Technical Memorandum

To: Mr. Thomas Walker, FCAA Director of Operations
From: W. Kirk Martin, P.G., Water Science Associates
Date: August 12, 2016
Re: Review of Groundwater Flow and Transport Model of the Biscayne Aquifer
Prepared by Tetra Tech for Evaluation of Remedial Measures to Address the Hypersaline Plume Created by the Cooling Canal System at the FPL Turkey Point Power Facility

Figure 1. Net recharge (inches/season) applied in the seasonal calibration model.

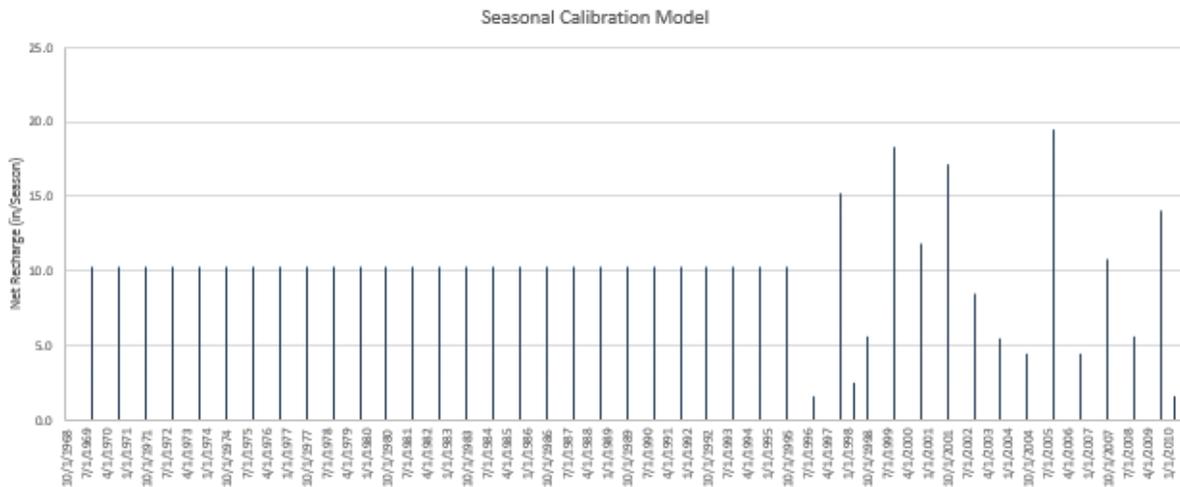
Figure 1 shows the net recharge applied in each stress period or season in the model at a selected location (R255 C21). It indicates that the most recharge occurs during the wet seasons as expected. A recharge of 10 inches per year in the wet season is applied uniformly from 1968 to 1995 whereas variable recharge rates are applied from 1996 through 2010 including net recharge being applied during the dry season in certain years. The technical memorandum does not indicate why the recharge rates were varied. Presumably, the change could be part of the calibration process. However, it is not clear why the recharge from 1968 to 1995 are uniform or why the change was made for years after 1995.

The net recharge in some years appears to be very high. For example, the net recharge was almost 20 inches in the wet season in 2005, which is about one third of annual precipitation. It should be noted that since the following figure only shows the recharge at one arbitrarily selected location, it might not necessarily represent the entire model area.

Figure 2. Dry cells in model Layer 1 at the end of stress period 1 in the monthly calibration model.

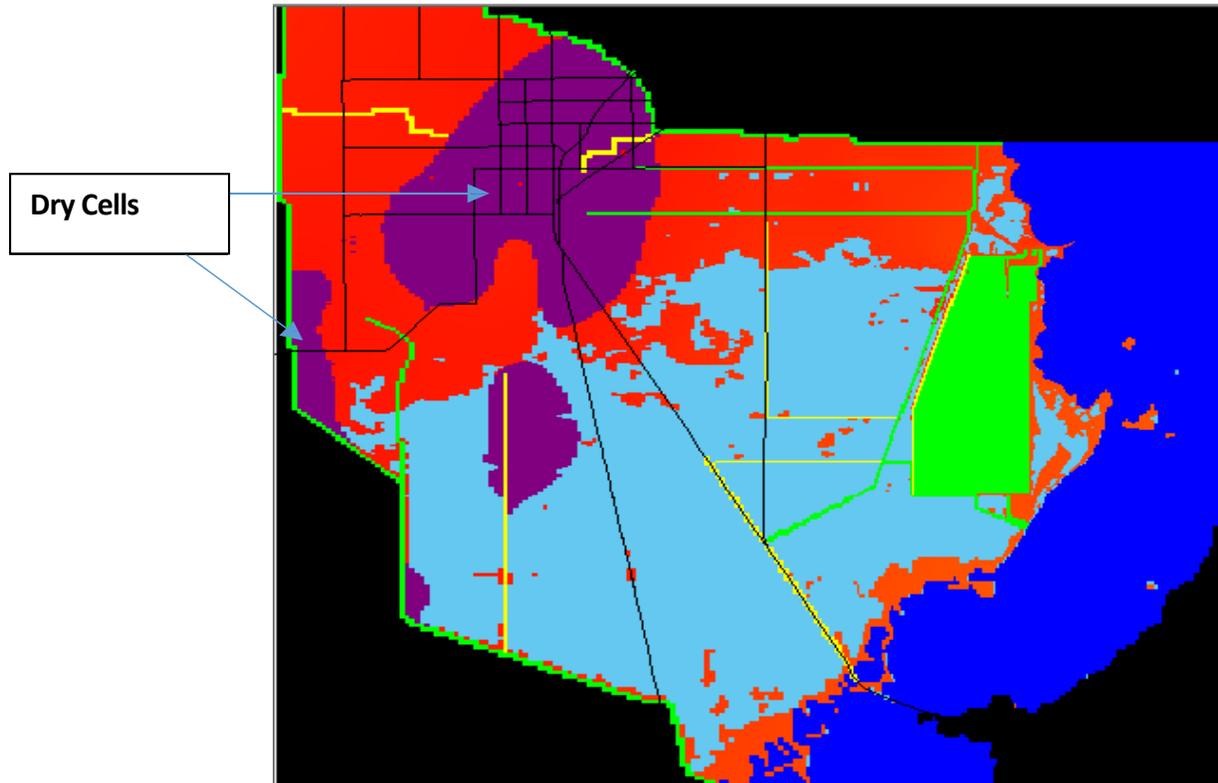
A large area of dry cells appears at the west side of the model with some dry cells appearing just after the first stress period in the monthly calibration model (Figure 2).

Observation of the dry cells indicates that the river conductance along the C-111 canal, where dry cells are present, may be too low. The larger dry cell areas, appearing only in Layer 1 may not affect the simulation results but the model developers should investigate the reason for the dry cells.

Figure 3. Simulated water levels (ft, NGVD) for December 2015, in Layer 8.

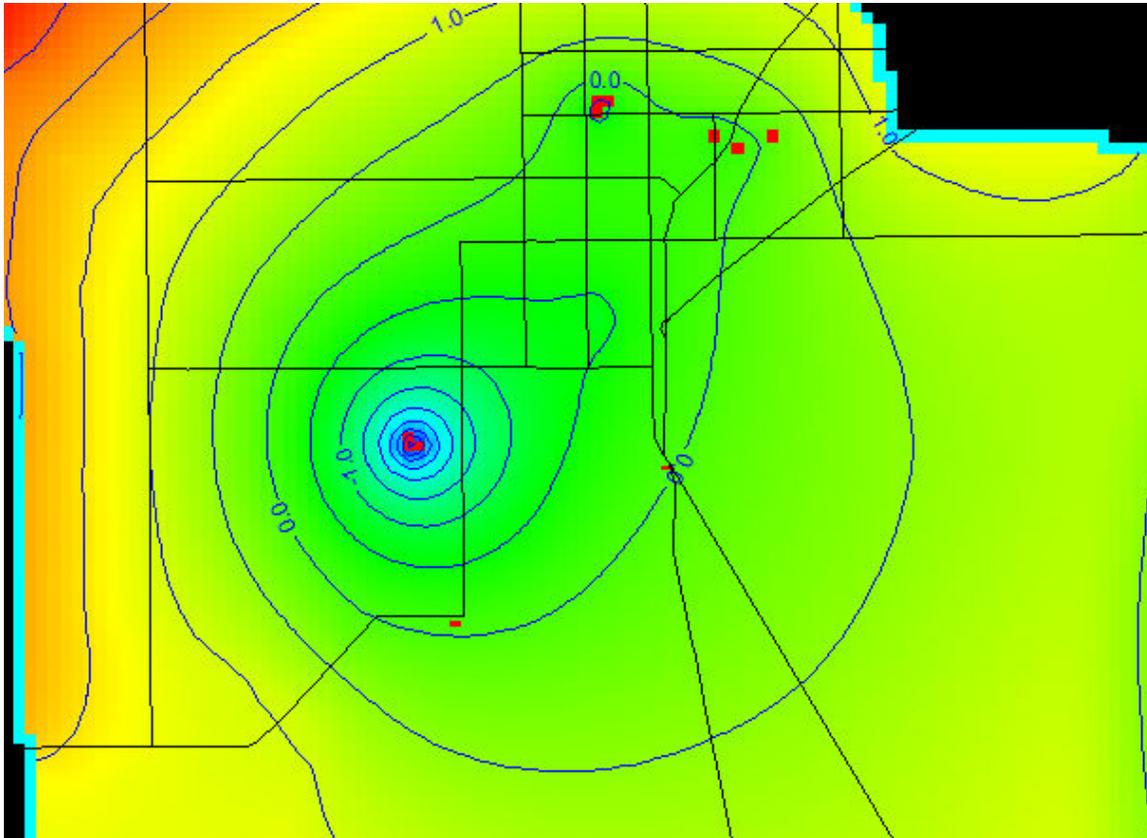
The model results also show a large area of drawdown due to withdrawals from the FKA wellfield (Figure 3). Such a large extent of cone of depression is not consistent with field measurements and likely represents an inaccurate simulation of the wellfield influence in an area of extremely high transmissivity. The effect of model boundary interference with wellfield drawdown may also be indicated.

Figure 4. Net recharge (inches/season) applied in monthly calibration model.

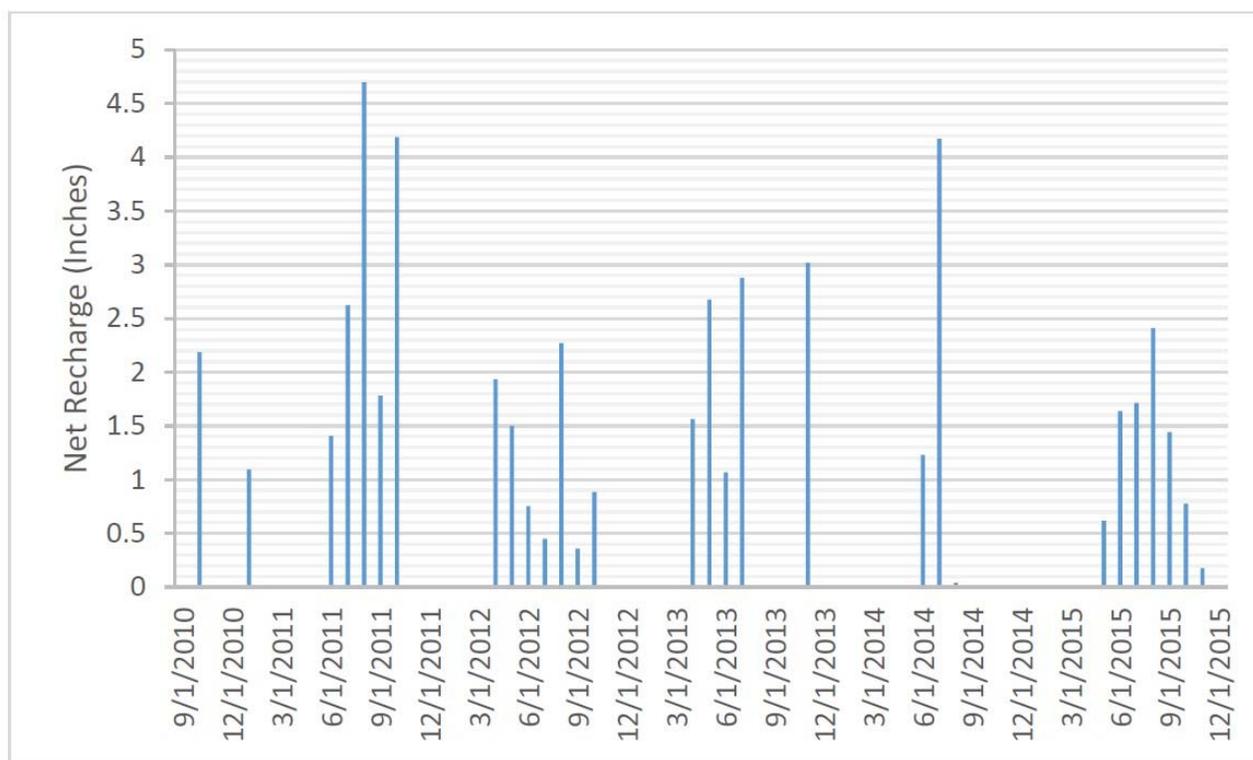
In addition to the dry cells, the model results also showed large areas where the cells were “flooded” when calculated water levels were above the land surface. The flooded cells may be caused by inadequately accounting for evapotranspiration in the model’s “net recharge” approach or by using non-representative hydraulic parameters in the shallow layers. Monthly net recharge rates at a selected location (R155 C21) are presented on Figure 4.

Figure 8. Performance of individual extraction wells in ALT3D (near UIC well is not shown).

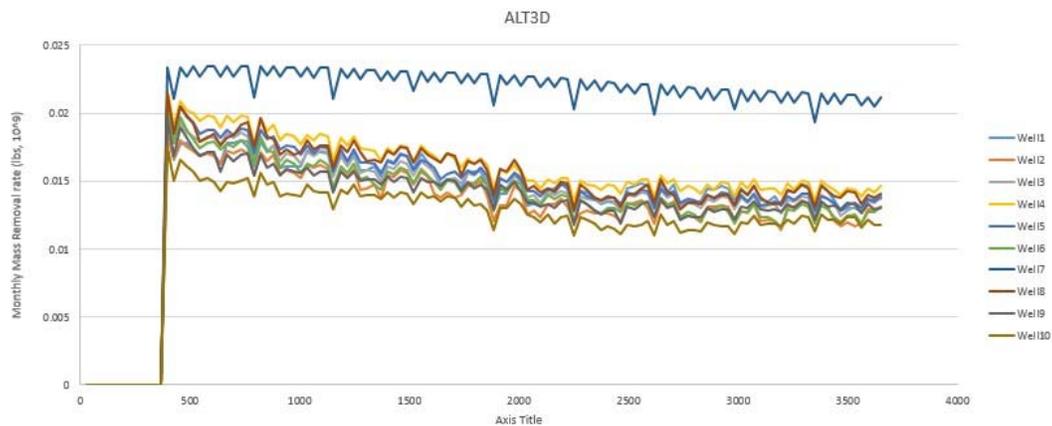
The performance of individual extractions (except the near UIC well), at the monthly mass removal rate, is shown on Figure 8. The proposed extraction rates for ALT3D scenario is provided in Table 4. It seems most of these proposed extraction wells behave similarly except for Well 7. The reason for better performance at Well 7 should be investigated. It follows that optimal location of proposed extraction wells may be determined by looking into the performance of each well.

It would be of interest to see if a higher efficiency of extraction of the hypersaline plume and seaward movement of the saline water interface could be achieved with the location of the extraction wells more towards the middle of the hypersaline plume. It would also be beneficial to look at the mass removal rate of each extraction well, as shown in Figure 8 for ALT3D, to optimize the remediation system design.

Figure 11. Simulated head changes in model Layers 1-4 in seasonal calibration model.

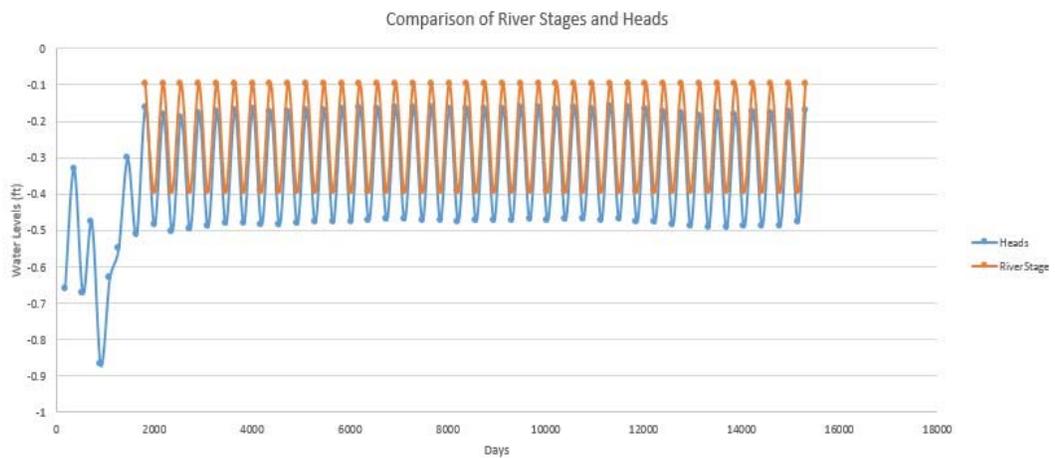
Layers 1 through 11 are hydraulically well connected and water levels in these layers fluctuate in a similar fashion. As indicated on Figure 11, a slight offset of about 0.05 feet is noted between the simulated water level in Layer 1 and stage values in the canal. The salinity in the aquifer is also very similar to the salinity specified in the CCS at the selected location as indicated on Figures 14 and 15.

Figure 15. Simulated salt concentration changes in model Layers 5, 7, 9, and 11 in the seasonal calibration model.

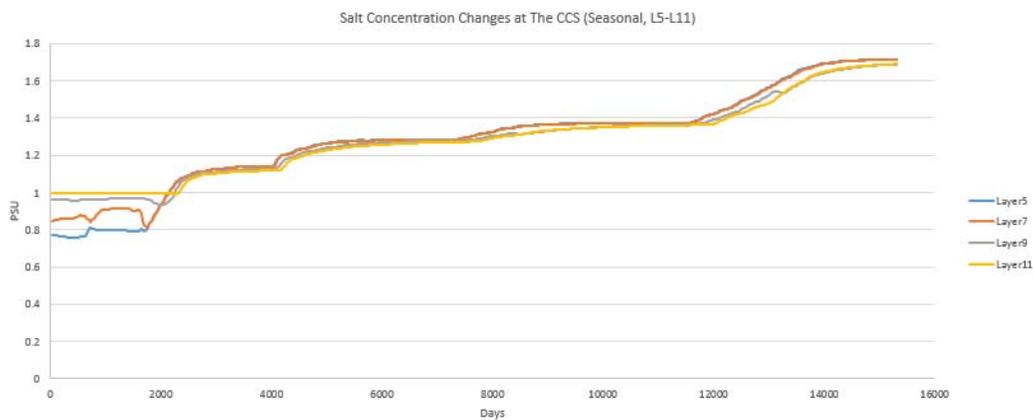
As shown on Figure 15, the maximum salinity in the CCS simulated in the seasonal model is about 1.8 PSU. It is relevant to note that salinity as high as 3.0 PSU has been reported for CCS (Chin, 2015). Higher salinity, up to about 2.7 PSU as shown in Figure 17, was applied to the CCS in the monthly model. However, due to change in canal conductance at that time, the salinity in deeper layers appears to not be impacted by the salinity in the CCS. It needs to be understood why the simulated salinity does not match the observed peak salinity values in the canal and how the low conductance in canal post 2013 is affecting the salinity in lower model layers.

Figure 16. Simulated water levels in the CCS canal and model Layer 1 in monthly calibration model.

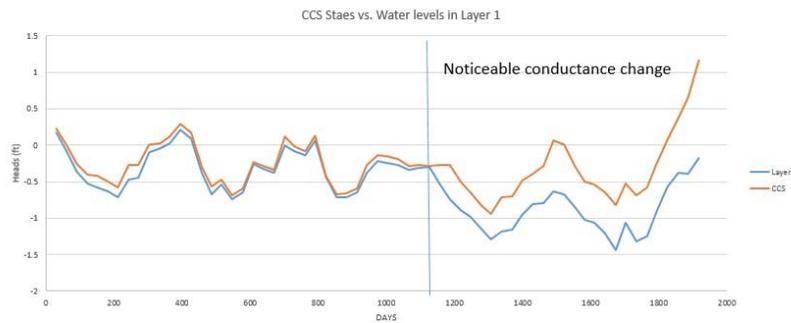
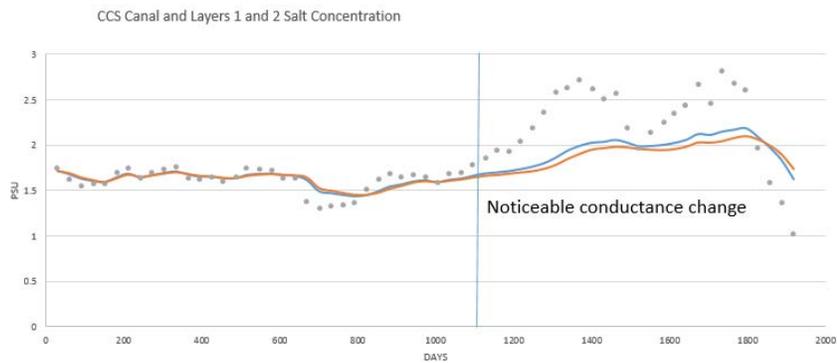
was made towards the end of the calibration period, and it seems to have occurred only at the CCS area. However, the change indicates a very different set of conditions for the remediation simulations as compared to the model calibration efforts. The impact of this change may also significantly affect the simulation results as shown in Figures 16 and 17.

Review of the figures indicates that the simulated heads and salinity start to deviate from the values specified in the CCS after the river conductance values are reduced. This impact is also observed in the model calibration time series (from the Tetra Tech PowerPoint presentation presented as Figure 18).

Figure 18. Salinity calibration results of the monthly model (Tetra Tech, 2016).

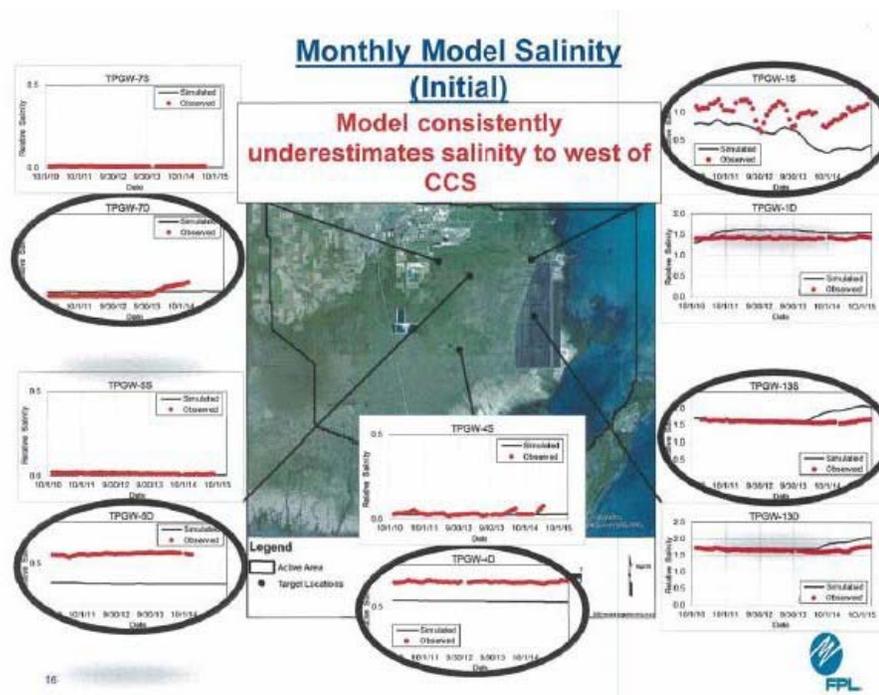
As shown above, simulated salinity values in the calibration target monitor wells, TPGW-13S and TPGW-13D, started moving away from observed values at approximately the end of 2013. Another monitoring well, TPGW-7D, located a significant distance away from the CCS, also showed a similar pattern change. The revised river conductance values for the CCS were used in all of the predictive models. This is a concern. The change of the river conductance beneath the CCS was significant and made at a very late stage of the model calibration period. The reduced river conductance may not be representative of actual field conditions and was not considered during most of the model calibration period. The validity of the prediction scenarios are therefore placed in question because of the significance of the change and the late stage of the change in the area most critical for performance evaluation of the proposed remediation measures.
